**UNITED STATES ENVIRONMENTAL PROTECTION AGENCY  
REGION 7**

On June 5, 2020, Parsons submitted revised versions of the Design Investigation Workplan (DIWP), the Field Sampling Plan (FSP), the Quality Assurance Project Plan (QAPP), and the Data Management Plan (DMP). These documents are required pursuant to Sections 3.6(a), 5.7(a), 5.7(d), and 5.7(e) of the May 6, 2019, Remedial Design Statement of Work (SOW) OU-1, West Lake Landfill Superfund Site.

B-Comments/Response to Revised DIWP

### EPA General Comments on the Revised Documents Associated with the OU-1 Remedial Design Investigation dated June 5, 2020

## Enclosure A Boring Modifications

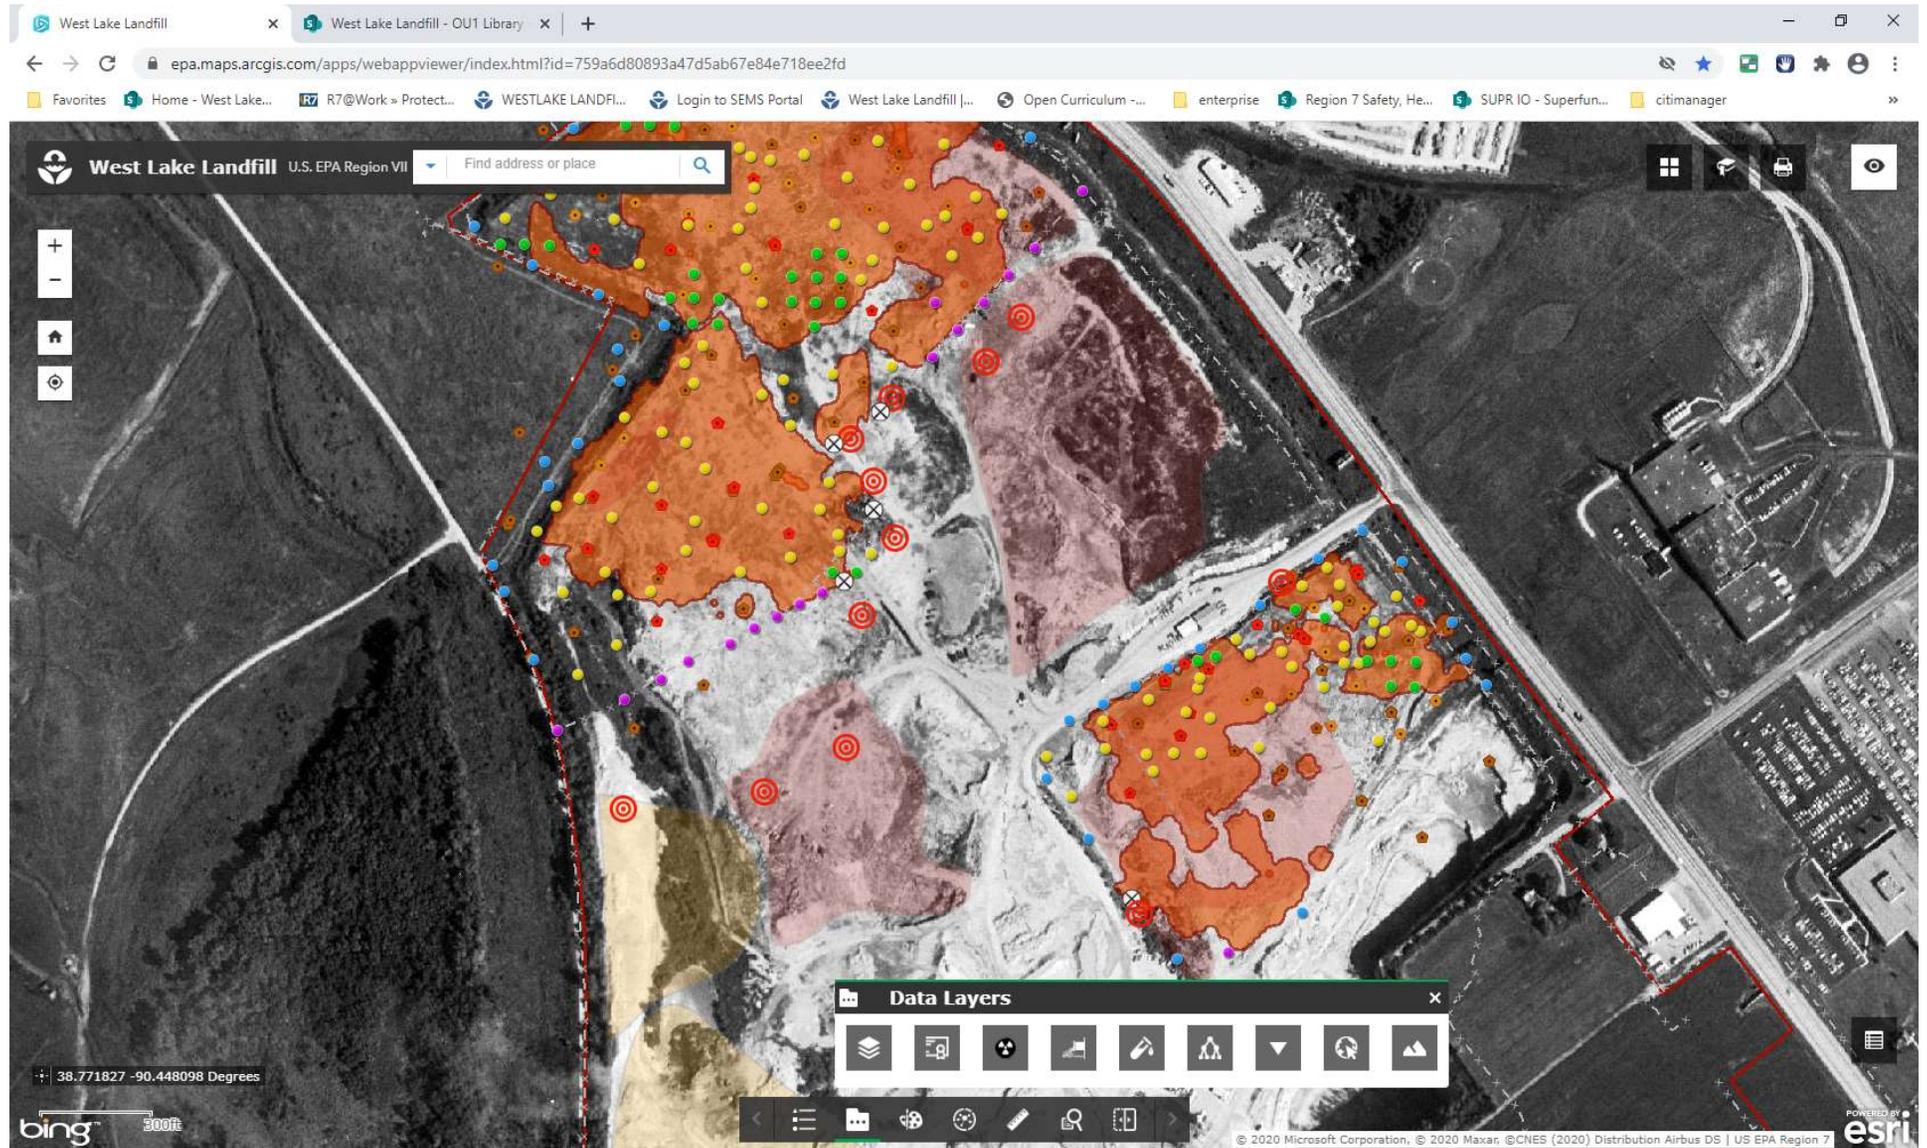
1. Delete the second sentence of the third paragraph.
2. Replace the June 5, 2020 Figure 10 that depicts the historical aerial photographs, the 1977 gamma flyover, and MDNR permit boundaries with the corrected Figure 10 previously submitted to the EPA via email dated July 2, 2020 from Ray D'Hollander, Parsons, to Chris Jump, EPA.
3. Replace the last sentence of the fourth paragraph with the following: *“In addition to radiological samples collected at depth, radiological samples will also be collected from the top 1-foot of select proposed perimeter borings as described in worksheet #11 of the QAPP and Tables 1 and 2 of the FSP.”*
4. Modify by deleting the seventh paragraph of this section.
5. Modify Figure 5 as follows:

- 1) Add a boring approximately 300 feet south of A2-PB-149 in the northwestern corner of permit area 218903R.
- 2) Add a boring approximately 400 feet southeast of A2-PB-148 perpendicular to the fence line in the northeastern portion of permit area 118903R.
- 3) Add a boring approximately 400 feet southeast of A2-PB-152 perpendicular to the fence line in the northeastern portion of permit area 118903R.
- 4) Move boring A2-PB-154 approximately 75 feet southeast from its proposed location, perpendicular to the fence line.
- 5) Add a boring approximately 100 feet southeast of boring A2-PB-145 along the boundary line.
- 6) Move boring A2-PB-145 approximately 75 feet northwest along the boundary line.
- 7) Move boring A2-PB-144 approximately 50 feet northeast along the boundary line toward A2-PB-143.

- 8) Move boring A2-PB-143 approximately 50 feet northeast along the boundary line toward A2-PB-142.
- 9) Add a boring approximately 100 feet southeast of A2-PB-157, perpendicular to the fence line, in permit area 218903R.
- 10) Add a boring approximately 100 feet southeast perpendicular to the fence line between borings A2-PB-141 and A2-PB-156.

- 11) Add boring at historical perimeter surface sample location 1015S based on surficial thorium at 31.17 pCi/g.
- 12) Shift proposed boring A1-PB-102 approximately 50 feet southeast based on historical data.

A figure is attached to depict the locations of the boring modifications.

**Exhibit 1.** The behavior of a gamma detector as it relates to contamination boundaries. *Adapted from Borehole Logging Methods for Exploration and Evaluation of Uranium Deposits (U.S. Atomic Energy Commission 1967)*

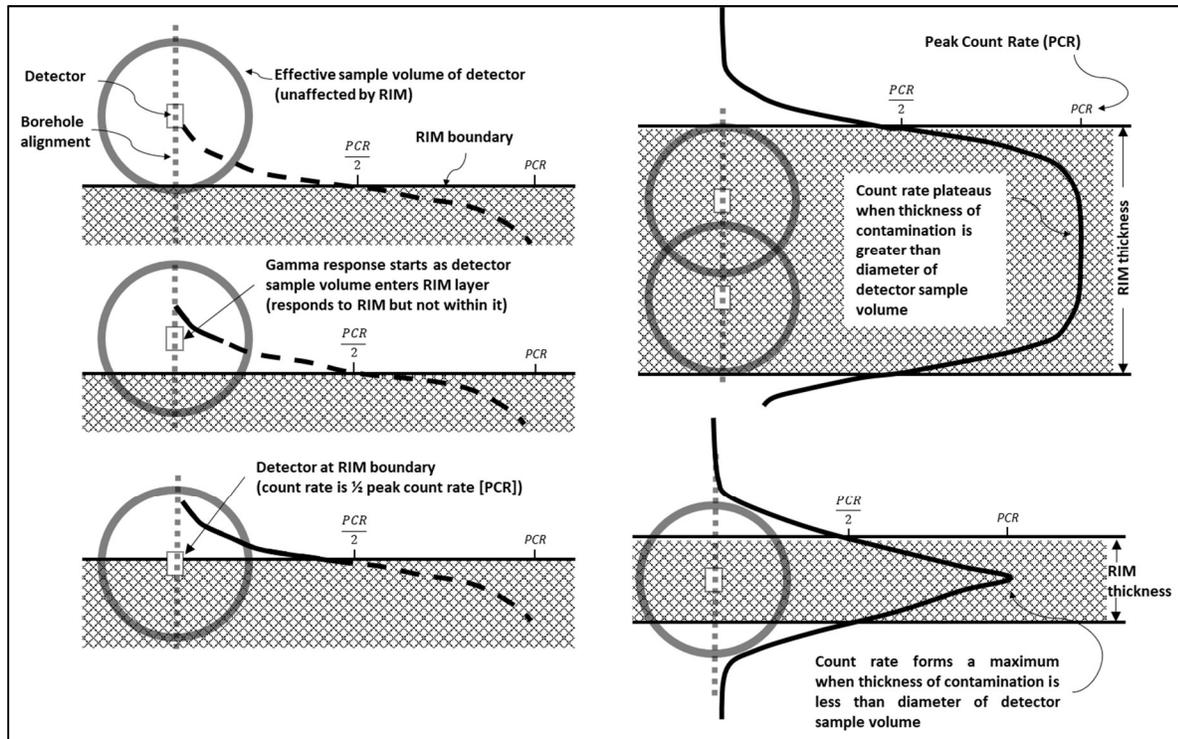
- a. As the gamma detector approaches a radioactive layer, the detector responds before reaching the layer. Thus, targeted sampling of mid-count ranges, especially if the sampled interval is the midpoint of a gamma response peak, may incorporate unimpacted material into the sample—possibly not the desired outcome of design of mid-range count targeted sampling.

- c. If thickness of the radioactive layer exceeds the diameter of the spherical volume the detector is sampling, the count rate will “level off” and plateau. If mid-range count intervals will be targeted for sample collection, the EPA suggests sampling intervals within which gamma responses plateau.

- d. If thickness of the radioactive layer is less than the diameter of the spherical volume the detector is sampling, the count rate will spike to a local maximum. Thus, a gamma response peak with no plateau may indicate a thin (relative to detector sample volume) layer. The EPA’s review of existing downhole gamma data has identified numerous spiked gamma responses with local maximums, indicating likely presence of RIM in thin layers (relative to detector sample volume). Unintended collection of unimpacted material at mid-range count intervals may be more likely within intervals with such gamma responses.

The approach to targeted mid-range count sampling must be revised with consideration of the behavior of gamma detectors discussed above, especially if the additional data will be used to update the empirically determined relationships of downhole gamma to activity. The EPA recommends intervals with characteristic plateaued gamma responses be sampled.
